Re: 4824 Edgemoor Lane
Sketch Plan No. 320200020 and Preliminary Plan No. 120200070

RE: Sketch Plan No. 320200020
Preliminary Plan No. 120200070
4824 Edgemoor Lane

DATE: 28-Jan-20
TO: Stephen Crum - scrum@mhgpa.com
Macris, Hendricks & Glascock
FROM: Marie LaBaw
RE: 4824 Edgemoor Lane
120200070

Re: Stormwater Management **CONCEPT** Request
for Edgemoor
Preliminary Plan #: 120200070
SM File #: 285454
Tract Size/Zone: 0.18 Ac./CR-2
Total Concept Area: 0.26 Ac.
Lots/Block: P16/13
Watershed: Little Falls Branch

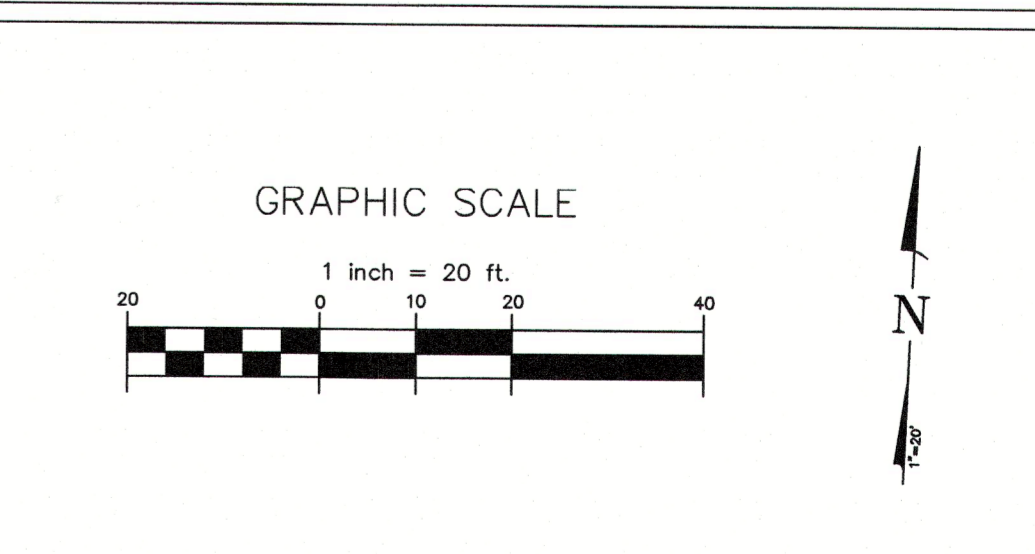
***** See Statement of Performance Based Design; Zero lot line condition with highrise building protections *****
